**ADDENDUM NO. 1**  
**May 21, 2026**  
**230693**

RE: **Charter Oaks Village Cooperative**  
**Arundel, ME**  
**Phase 1 Distribution Improvements**

FROM: DuBOIS & KING, INC.  
208 Union Avenue  
Laconia, NH 03246

**C10**

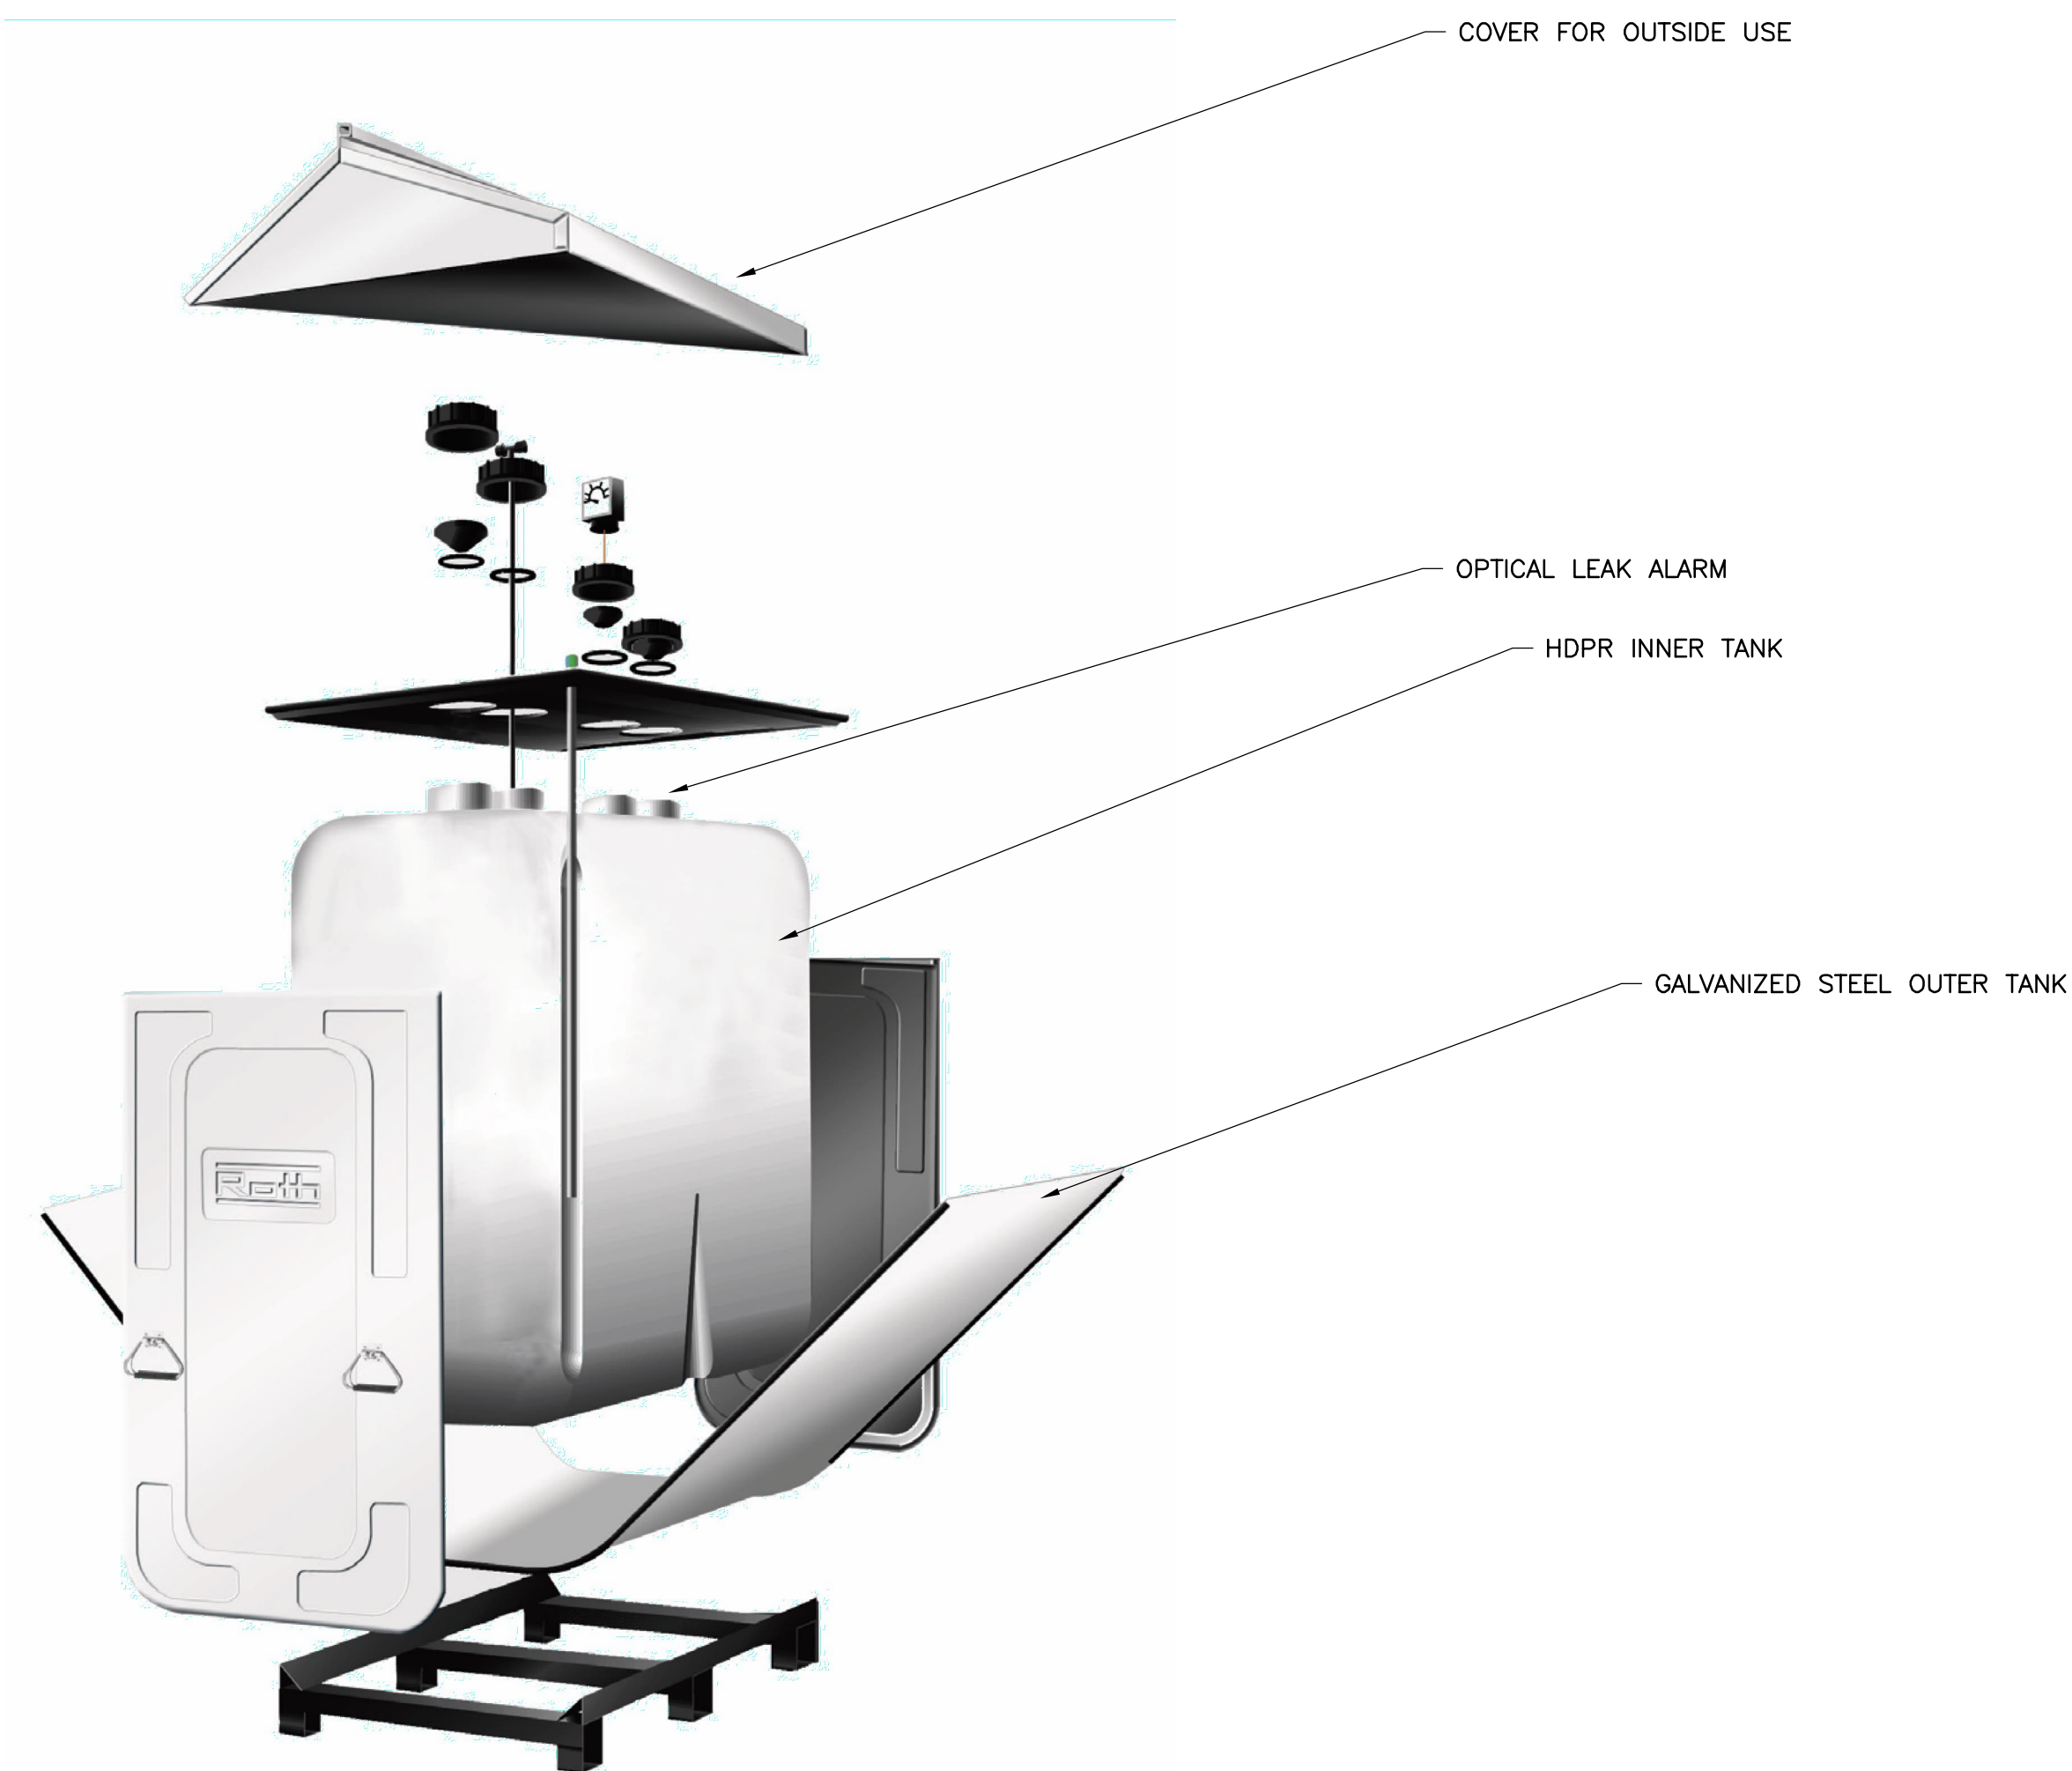
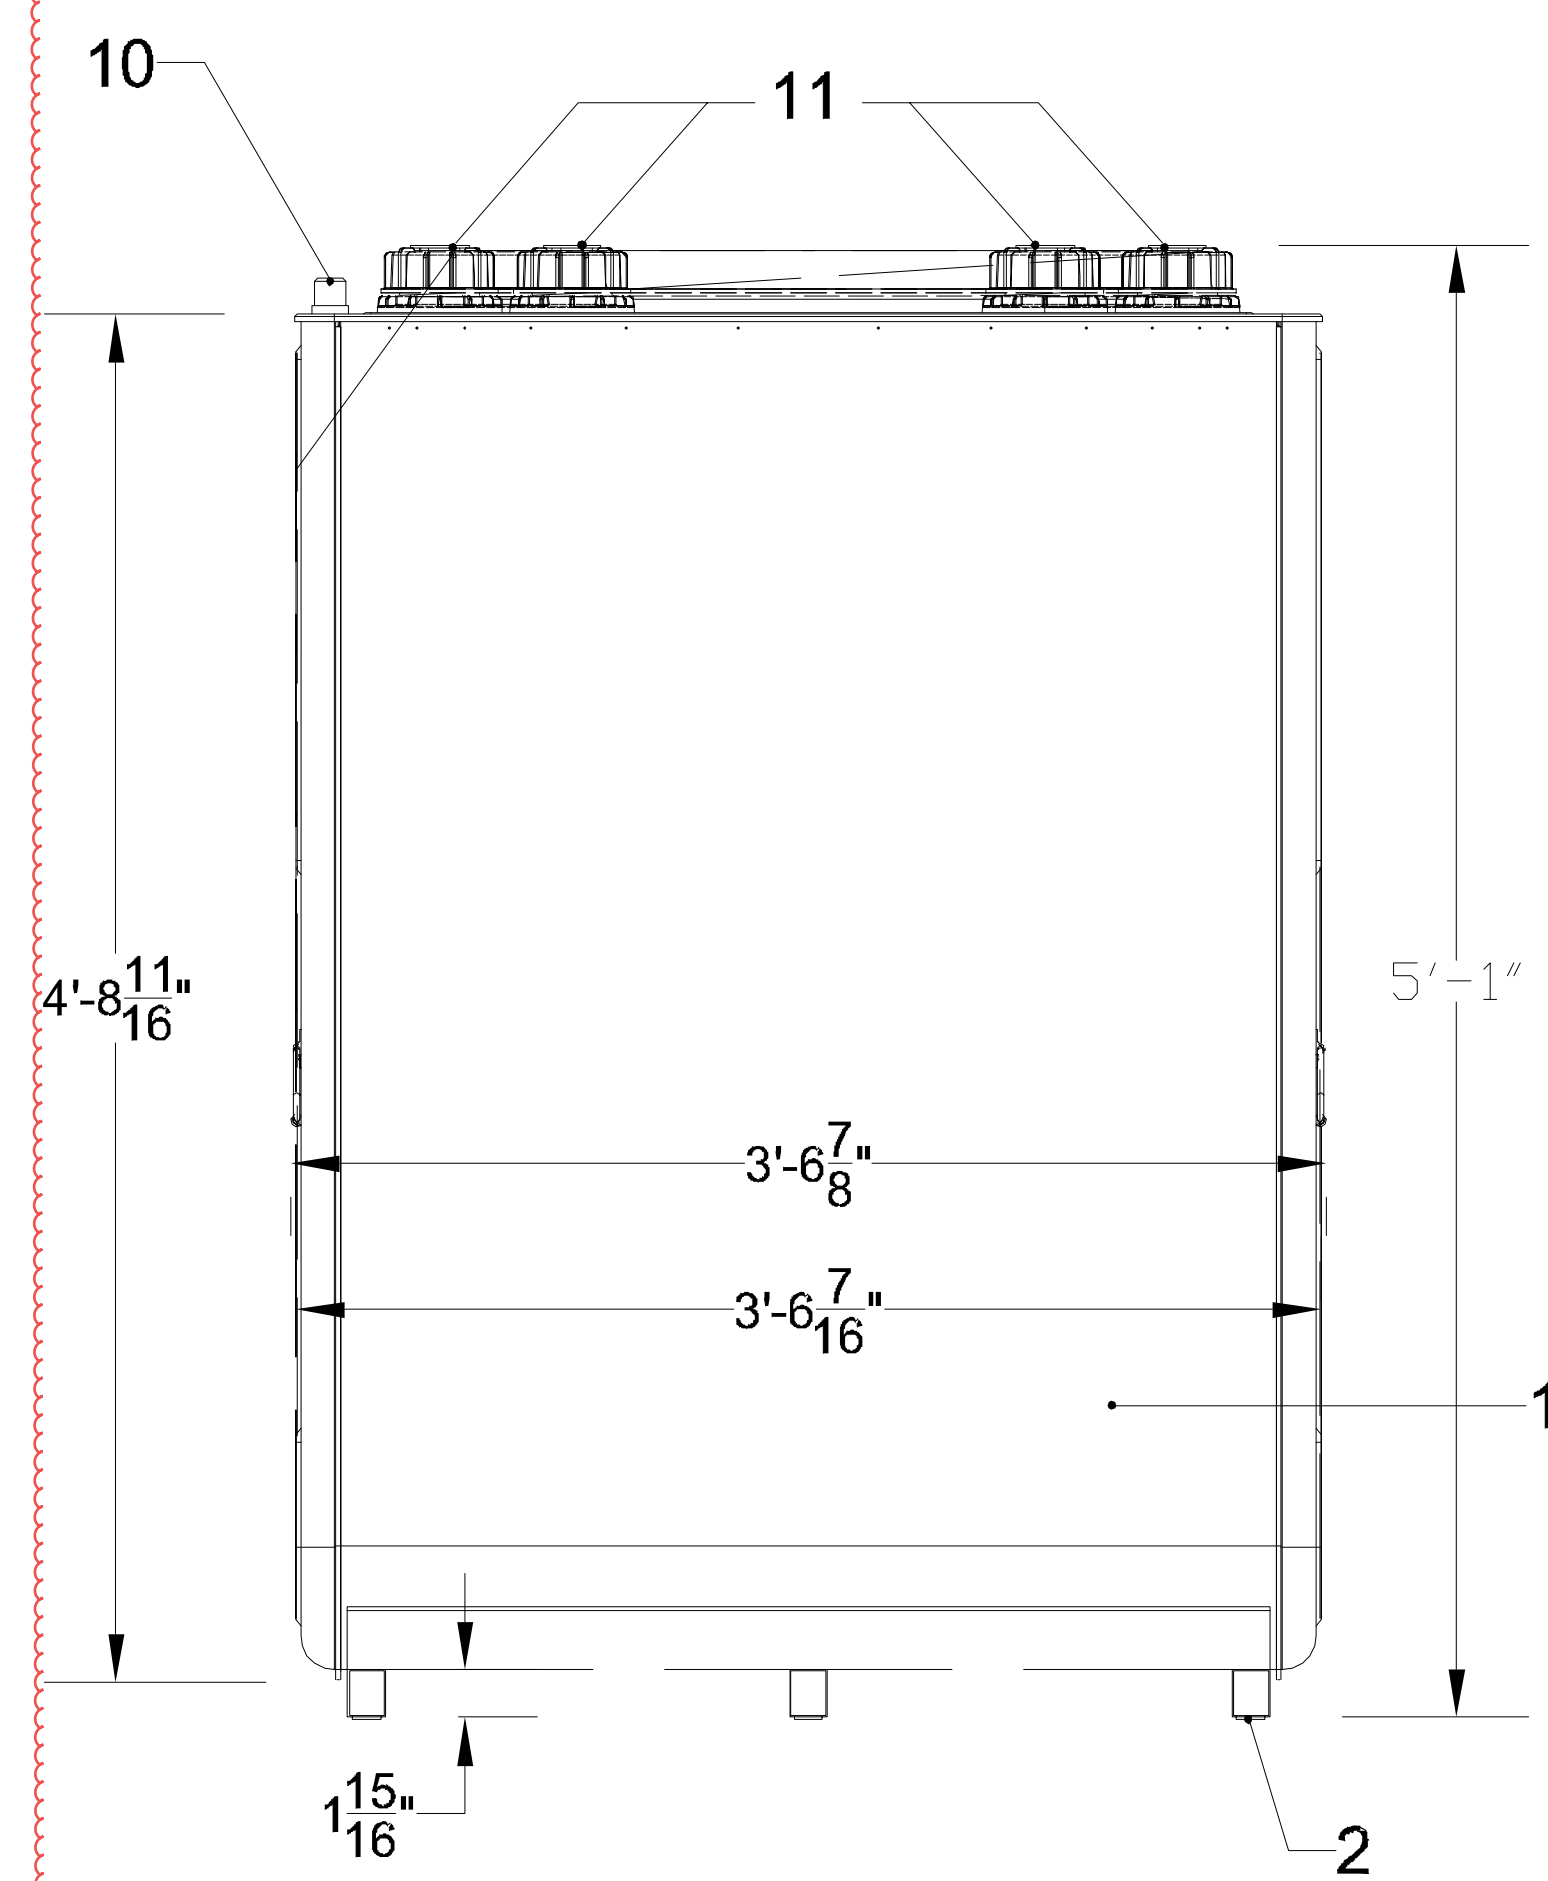
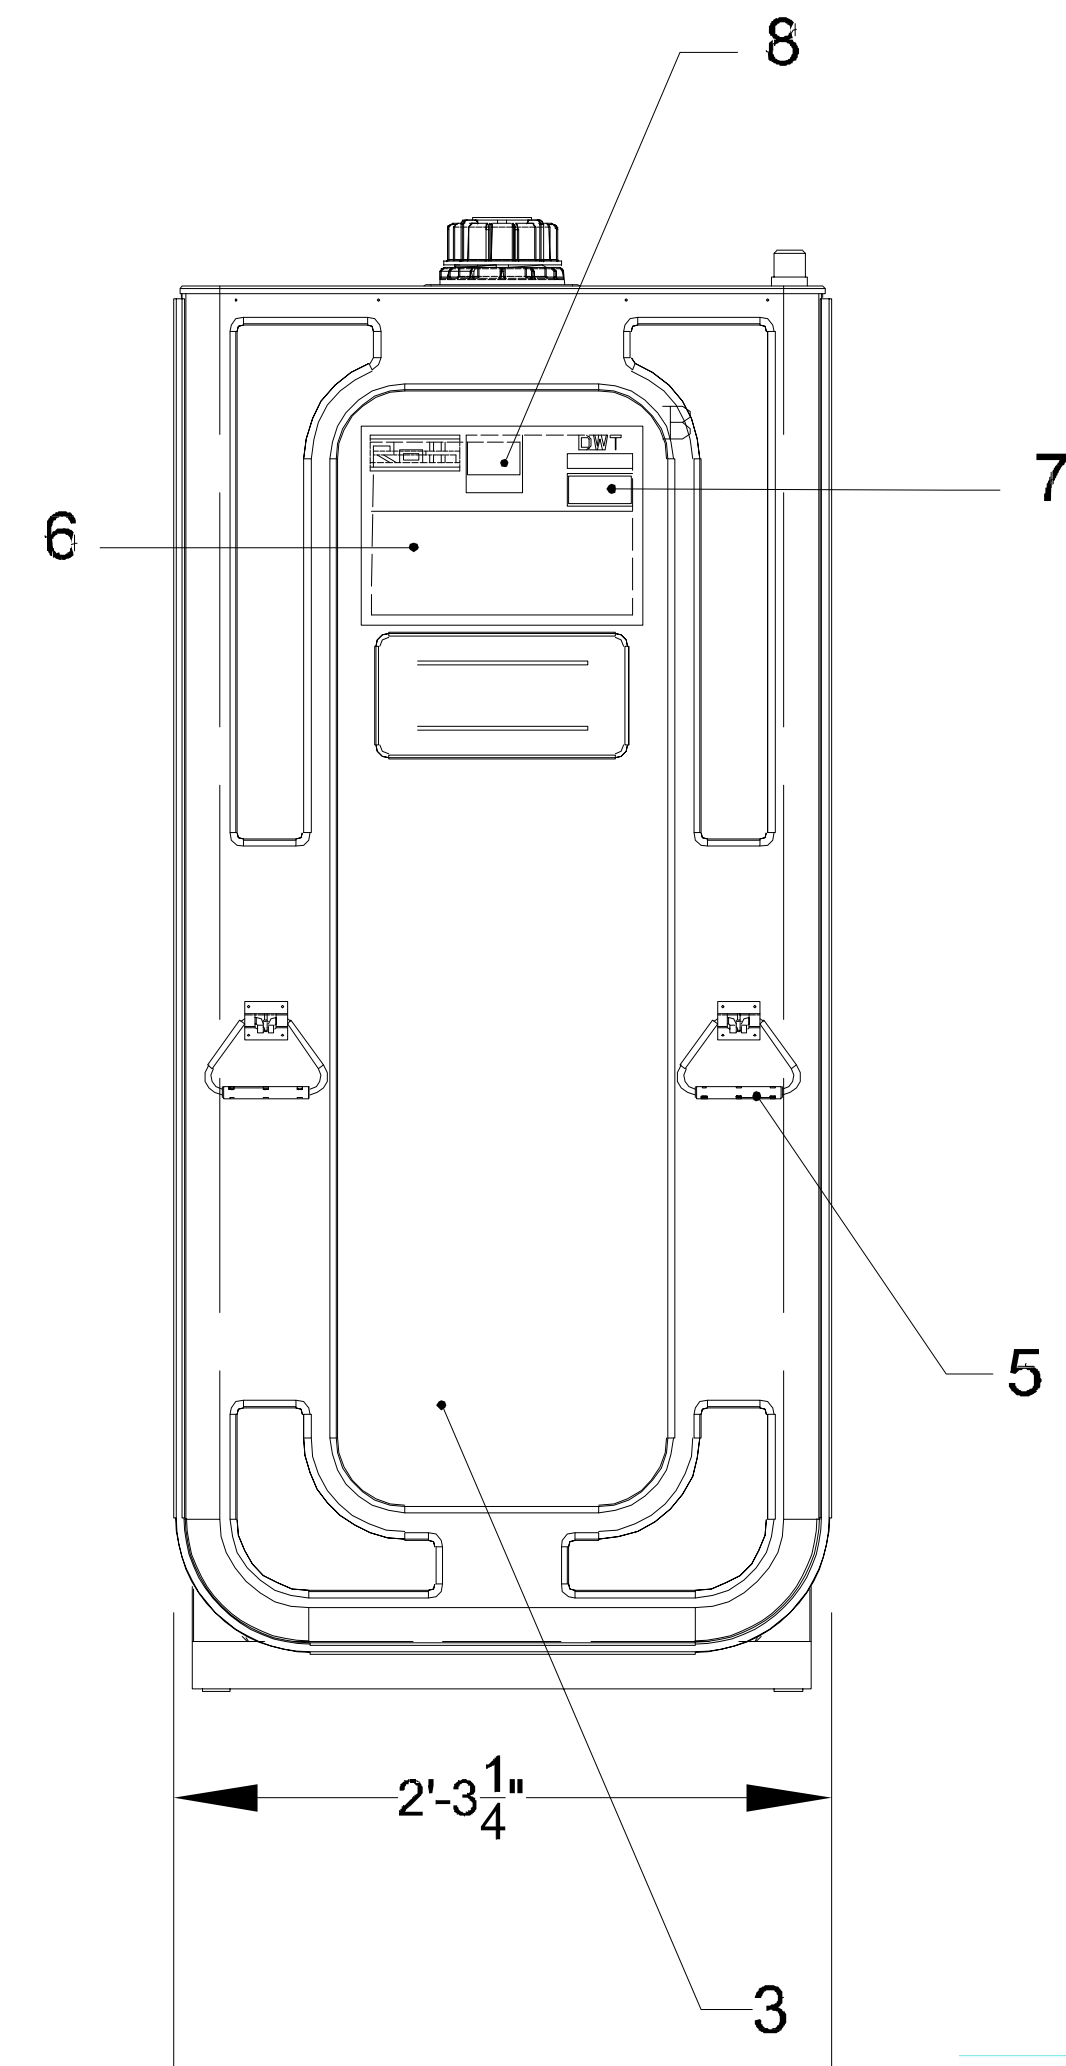
- New individual services were reconfigured to make it clear that no work is to be done under the home. (Sheet C2)
- A recently replaced septic system was added to the drawings as it is near a test pitting location and a connection point for the water main extension. (Sheets C3, C6)
- AST details were added to the plan set. (Sheet C10)

11. Question: What type and size tanks are specified? Can we provide a detail and/or pictures of the cover, concrete pad, and tank? Are the new tanks double-wall, 275-gallon capacity units? Do you have a unit (like a Roth tank) already onsite to look at, or can you provide a photo/spec of the required structures?
  - a. **Answer: A double-walled, 275-gallon above ground fuel oil storage tank. We have added details as Sheet C10. The standard is Roth DWT 1000L with cover or approved equal. Tanks shall be fully covered by a sturdy, well-constructed roof that meets or exceeds building code requirements for snow load and is constructed out of non-combustible materials. Tanks are to be installed on a 4-inch concrete pad at least 10% larger than the dimensions of the tank.**

| REVISIONS | DATE      | BY  | REVISION DESCRIPTION |
|-----------|-----------|-----|----------------------|
| 1         | 5/21/2026 | SAW | ADD SHEET TO BID SET |
